RE: Addendum #1 25-27 FY25 Annual Resurfacing Phase 1 – Local Roads

Please accept this as Addendum No. 1 for the above referenced solicitation.

FY 25 ANNUAL RESURFACING
PHASE 1
(LOCAL ROADS)

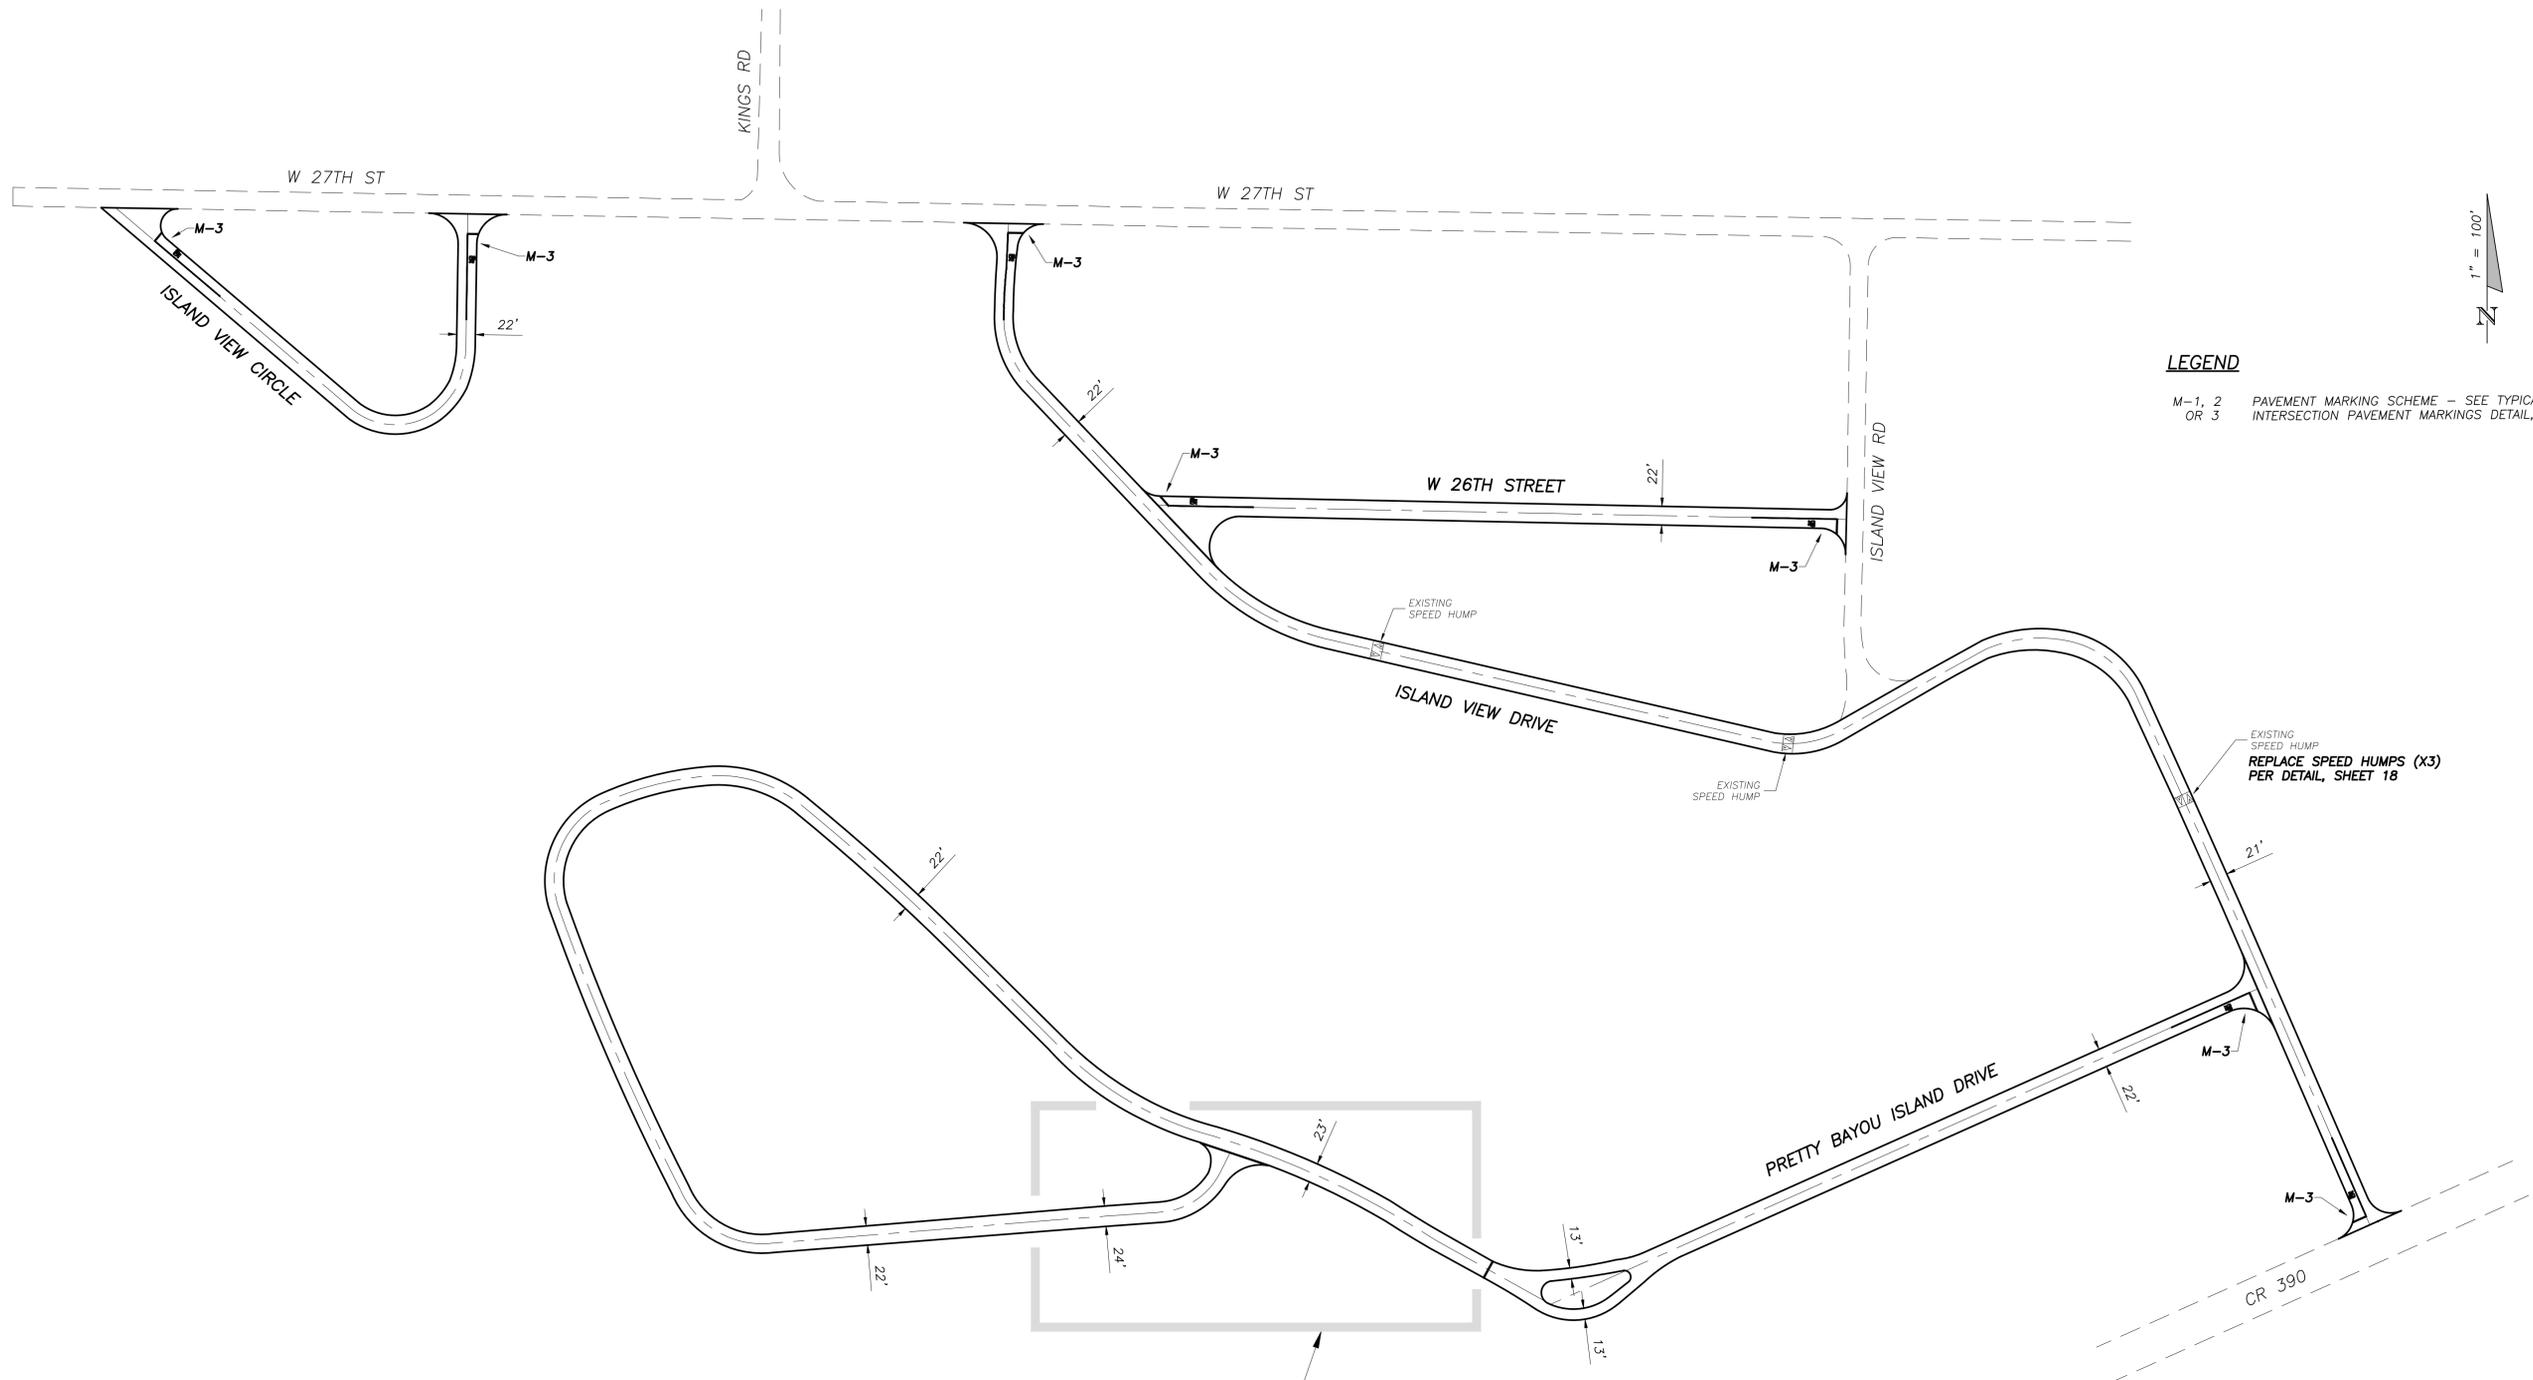
1. It appears there are no Plan Sheets for Island View, 26th and Island Dr. Was this the intent for the bid package? **Sheet #7 has the plan view for the above mentioned roads. There are no profile views because we aren't changing the profile of the road. See attached revised plans.**
2. Has the curb and new construction at SR 390 and Island View Dr, been accounted for in the bid quantities and construction limits? **No. The County intends on making the adjustment of the construction limits to end at the seam where the SR 390 construction begins.**
3. How thick is the concrete removal on Beach Wood Drive? **The concrete ranges from 4 to 5.5 inches.**

PLAN AND PROFILE (BEACHWOOD BLVD)					
SCALE AS SHOWN	DESIGNED BY MM/MR	DRAWN BY LW	SHEET NO. 12	PROJECT # 7655	
FIELD BOOK 731/35-76	CHECKED BY MM	DATE DRAWN 11/01/24	OF 19	PAGE # 2855

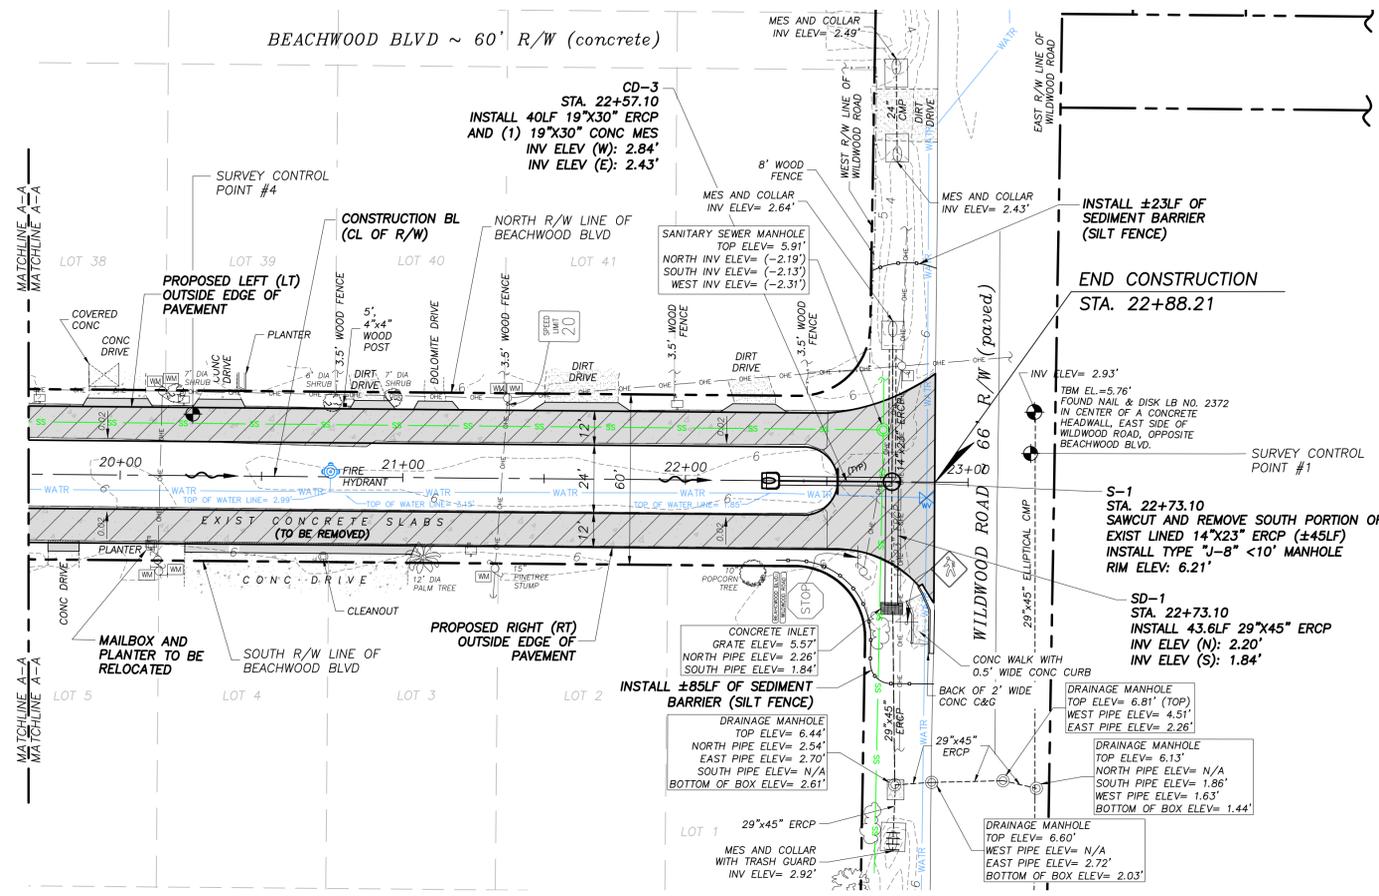
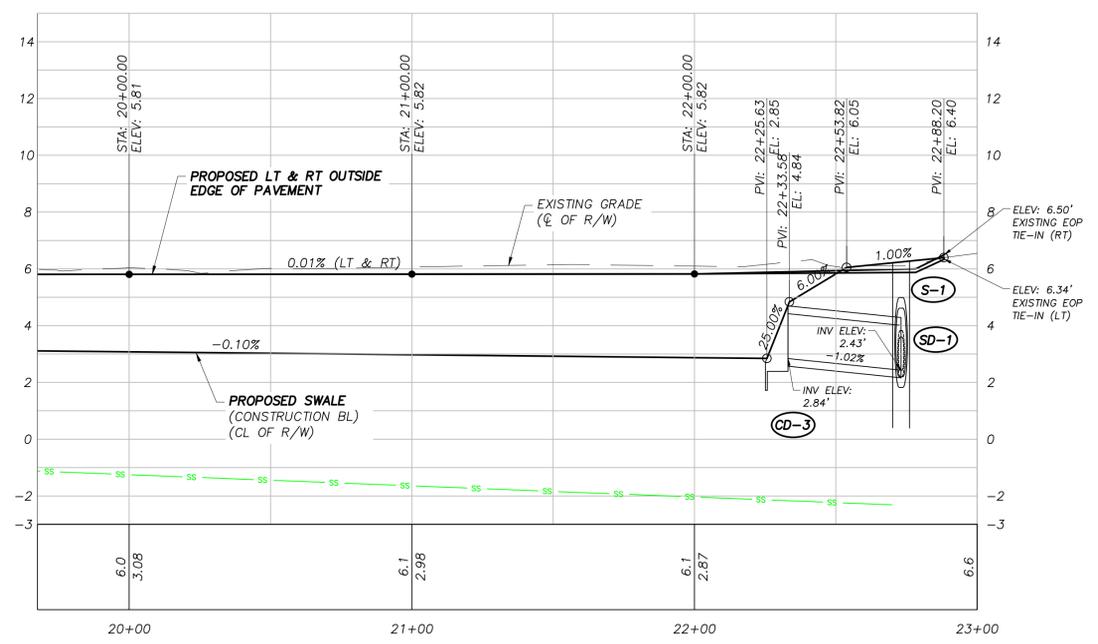
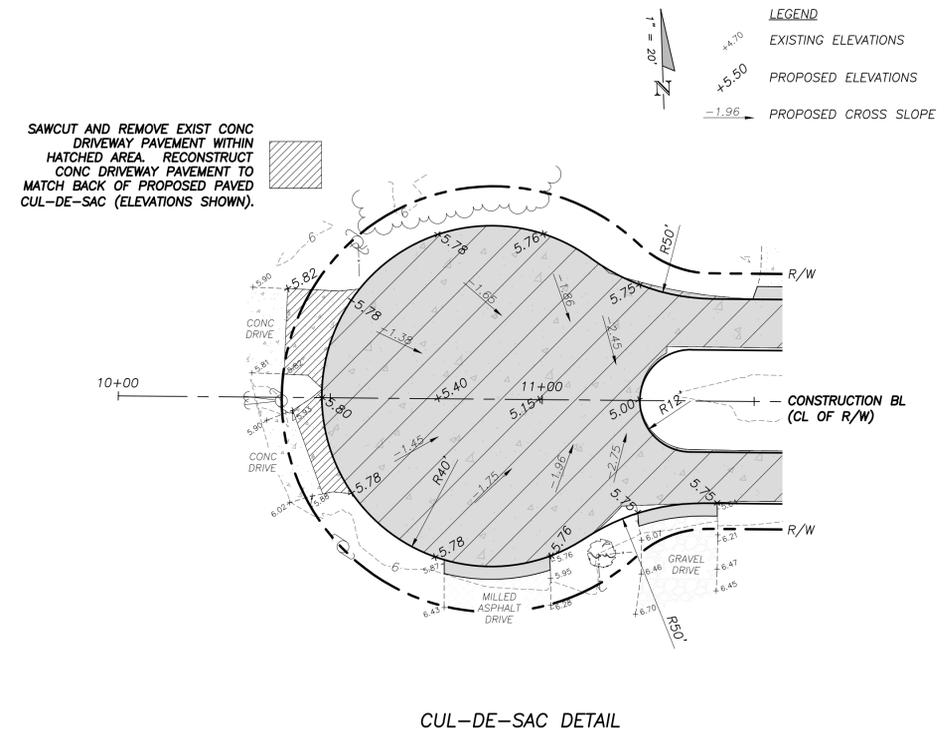
4. Should the Contractor plan to remove all trees within the new swell area on Beach Wood Drive? **Yes.**
